City of South Bend PLAN COMMISSION

AGENDA

Monday, June 15, 2020 - 4:00 P.M.

Proposed Site Plan

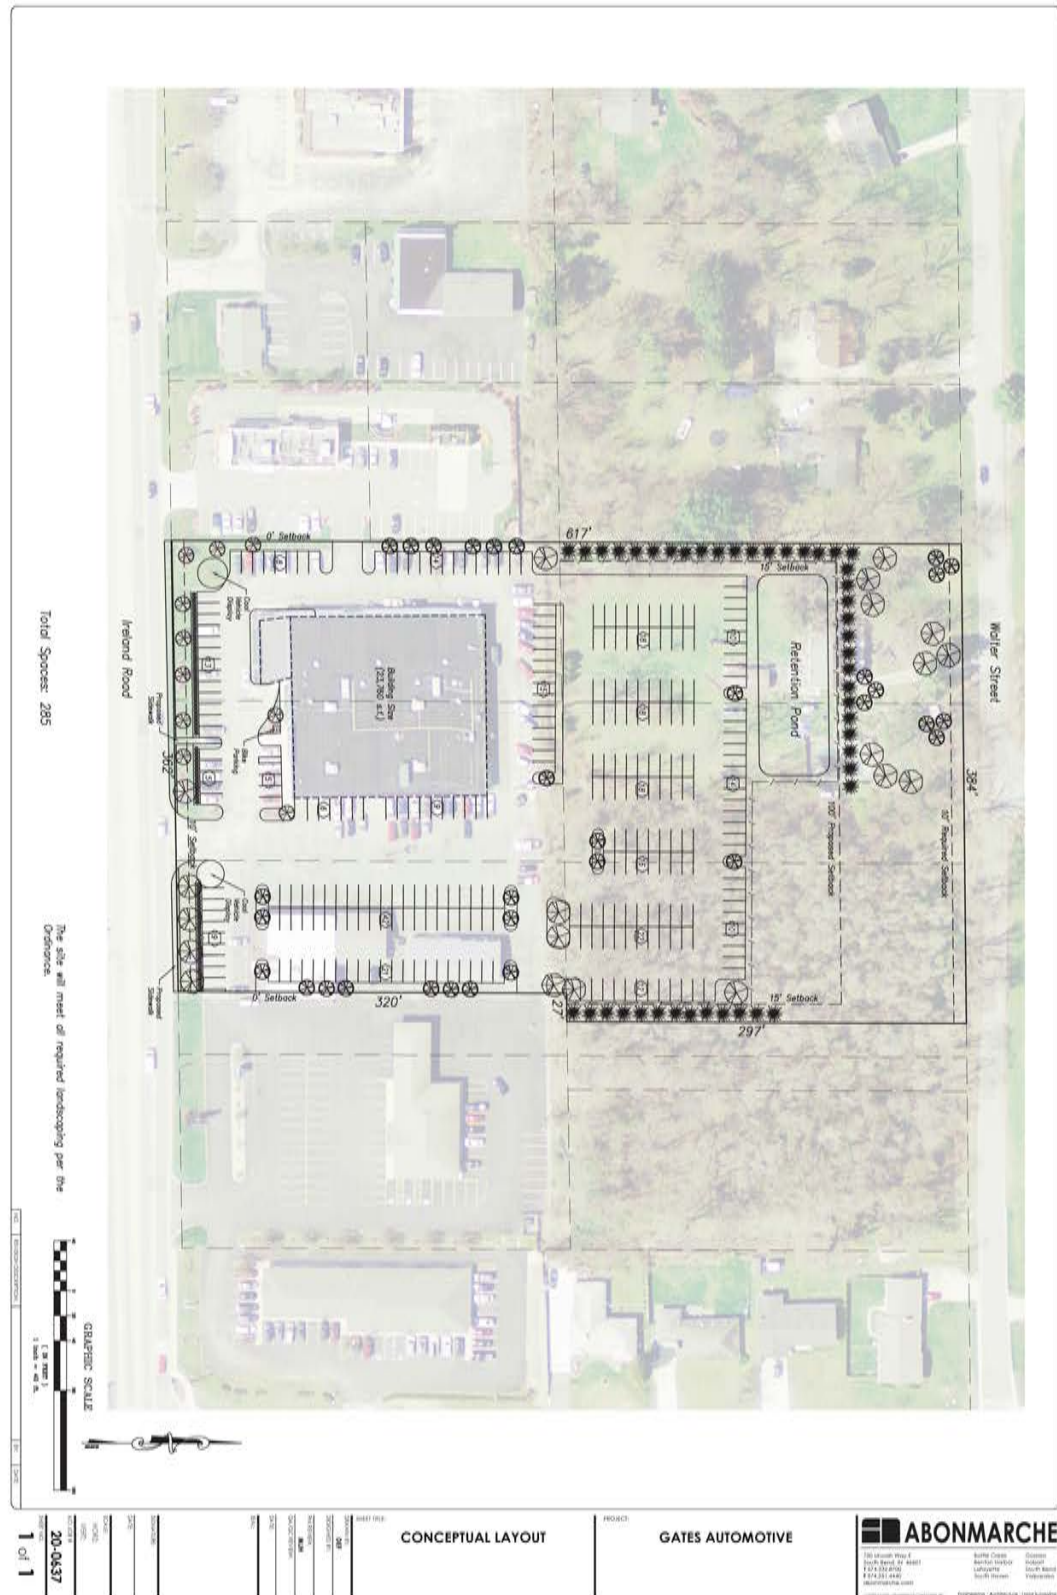
The site plan shows the southern half of the lots being used as outdoor storage of vehicles for sale. The storage area is arranged in a parking lot fashion with screening to the east and west. A proposed above ground retention pond is shown north of the parking area.

The Engineering Department recommends no access to Walter Street and notes that sidewalks will be required along Ireland Road.

Walter Street has remained a low density single-family area with an almost park-like feel. While we recognize the need for storage related to the automotive sales, careful consideration will need to be given to ensure the expansion does not degrade the character and feel of the area. The staff is recommending area to the north along Walter Street remain undeveloped in order to retain the current character of the area, but also note that it could be an ideal location for medium density residential.

Commitments: The staff recommends the following written commitments: 1) No access to Walter Street; and 2) Any development, including exposed drainage areas, shall be setback a minimum of 100' from Walter Street. A code compliance fence is excluded from this provision.

| SHEET TITLE: | PORTAGE PRAIRIE BUSINESS PARK PRIMARY PLAT |

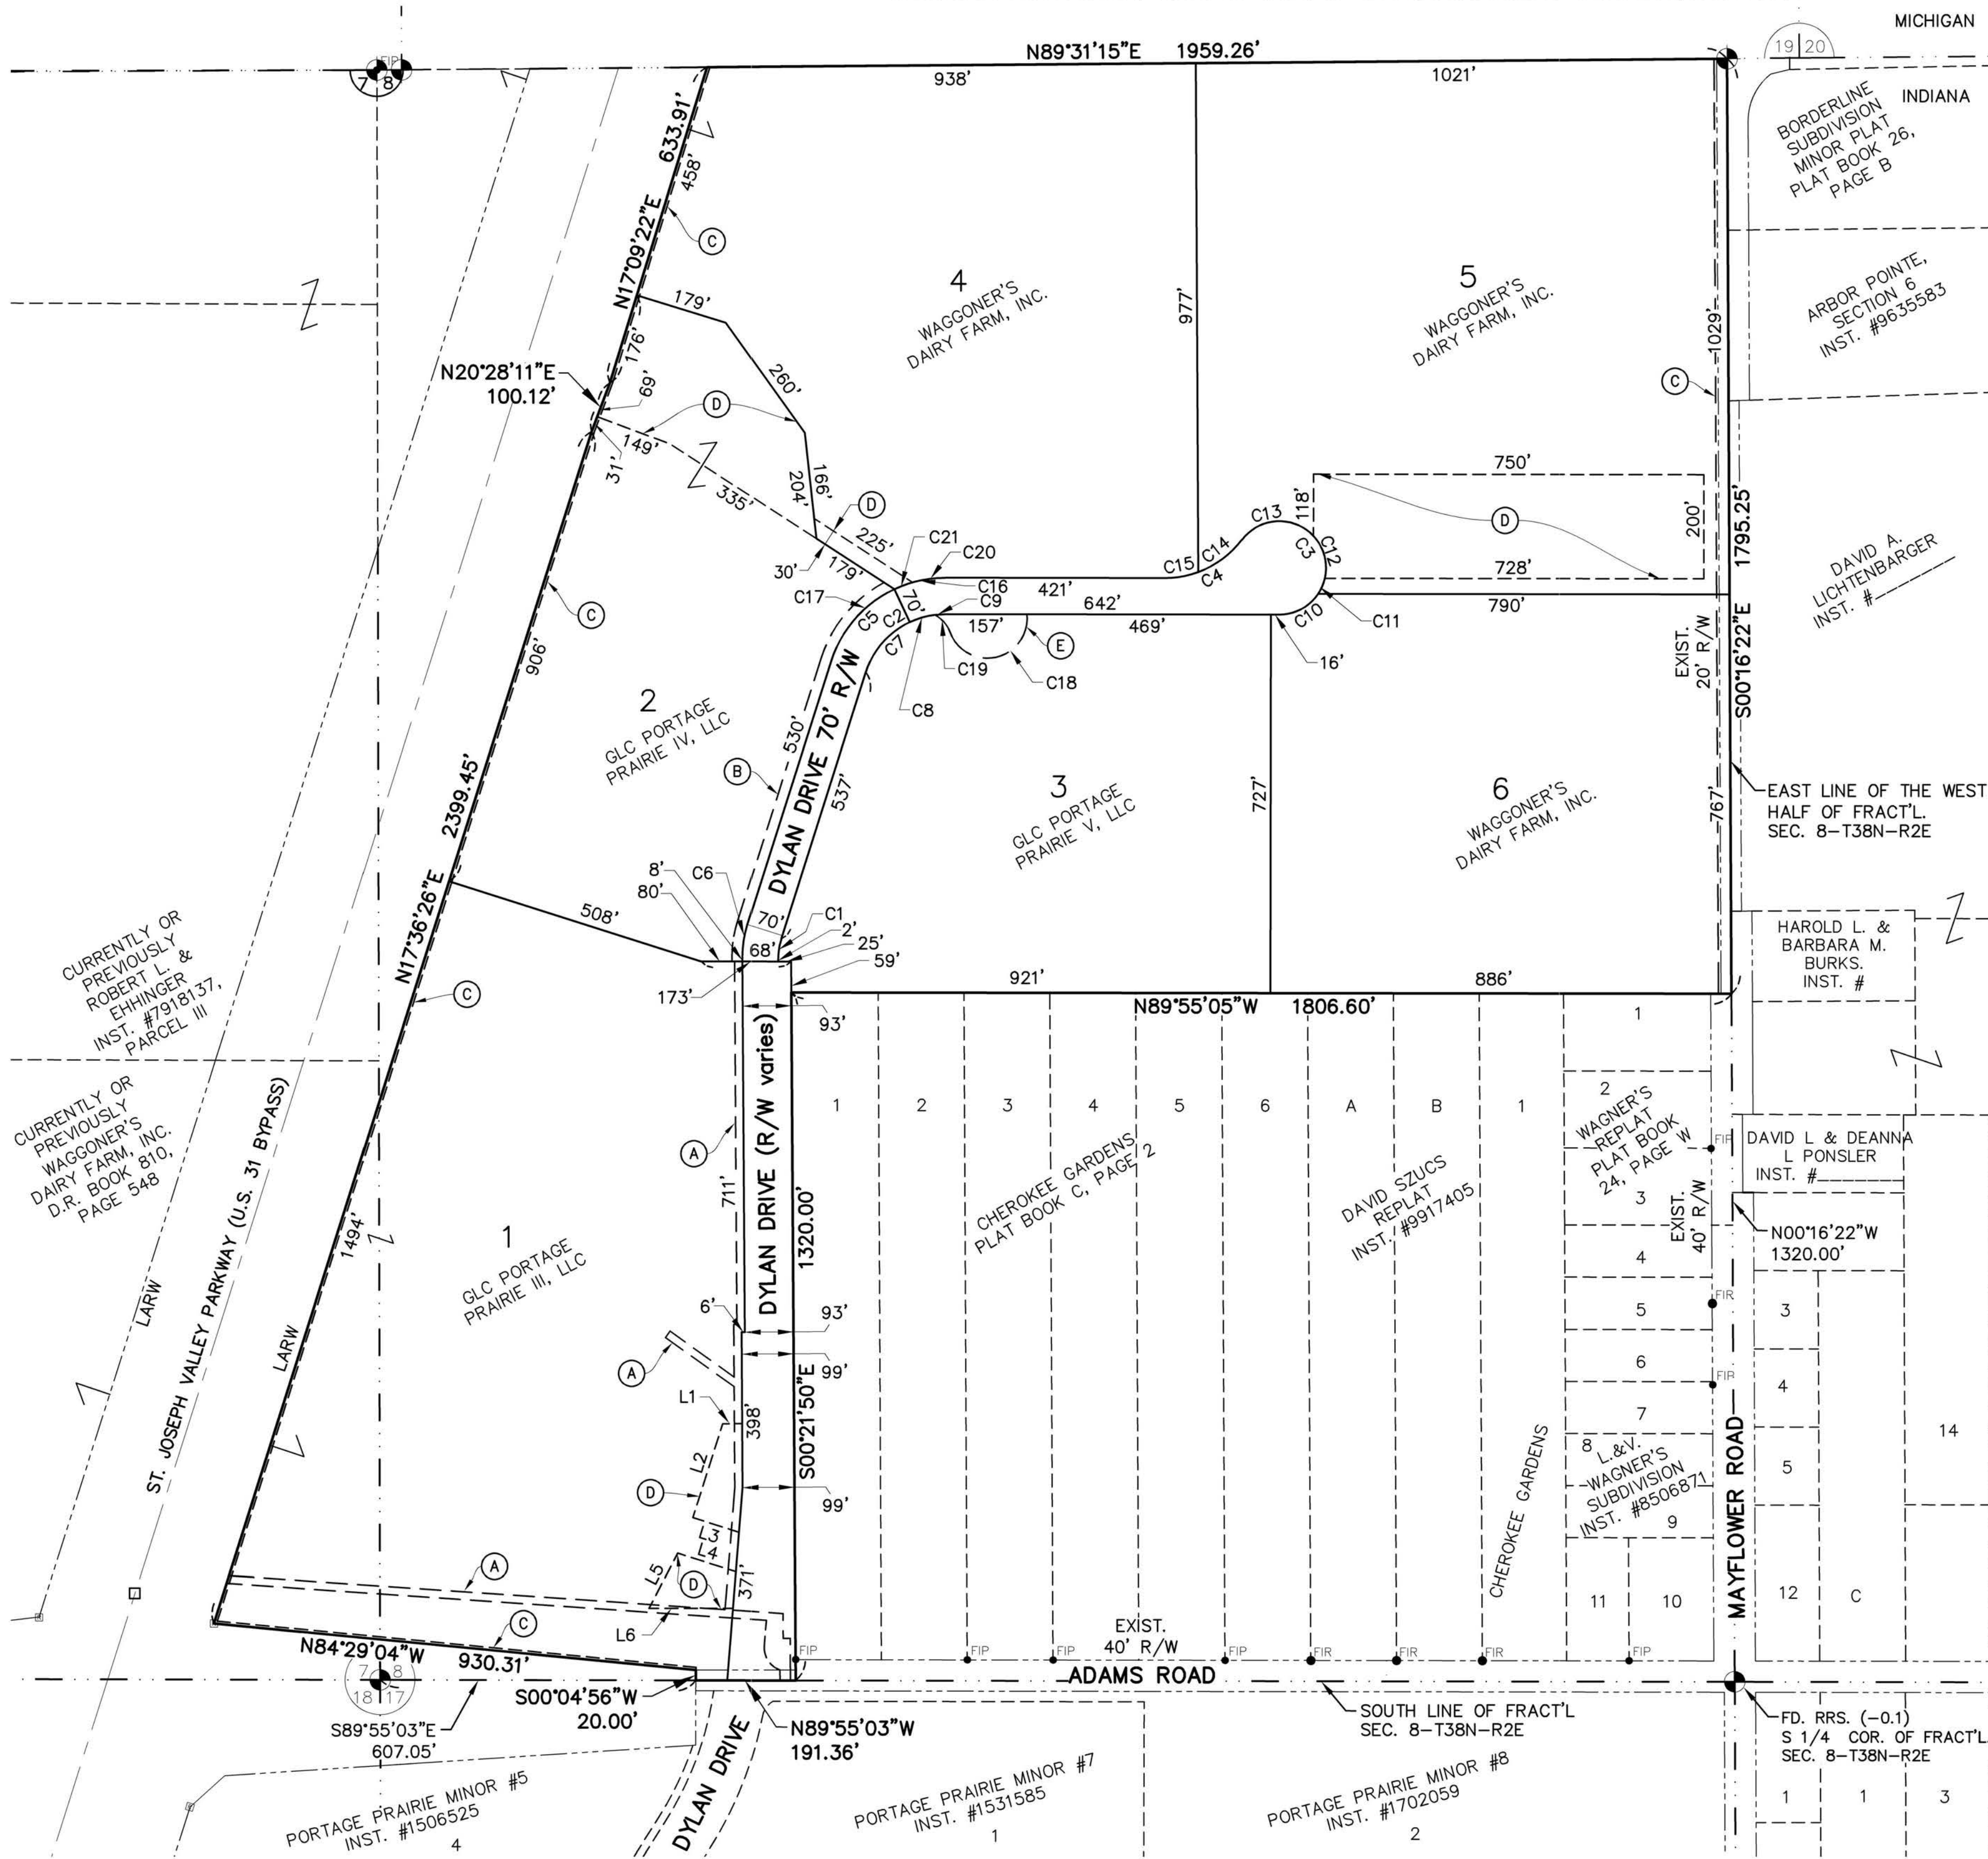
| Agency Comments: | The City Engineering Department recommends approval subject to the following: 1) Municipal easement is required between P2, 3 to maintain City storm infrastructure and end section that will drain Dylan to the basin, 30' is desirable.; 2) Verify that the future Dylan R/W width captures all existing infrastructure and appropriate space given to allow maintenance.; 3) Provide a utility plan showing the public extensions along Dylan to the end of the cul-de-sac and indicate how they will serve future development, grades, pressures, etc; 4) Provide roadway data or plans showing the road widths proposed, roadway geometry, cul-de-sac radii, etc.; and 5) Remove the space capturing trees on the east side of the sidewalk along Dylan Dr. from City R/W |

Staff Comments: The petitioner is requesting the following waivers: 1) From Section 21-11.02(d)(5) to install a sidewalk on one side of the public street; 2) From Section 21-11.02(e)(2) to allow a subdivision without 10% public open space requirement; 3) from 21-11.04(b)(6) to allow a 2,924' cul-de-sac.

Staff Recommendation: The Staff has reviewed this subdivision and finds that if the waivers are granted and the conditions are met, it complies with the requirements for Primary Approval as specified by the South Bend Subdivision Control Ordinance. The Staff therefore recommends that this subdivision be granted Primary Approval, subject to the following: 1) Adding the waiver note to the plat; and 2) Addressing the comments from the City Engineering Department.
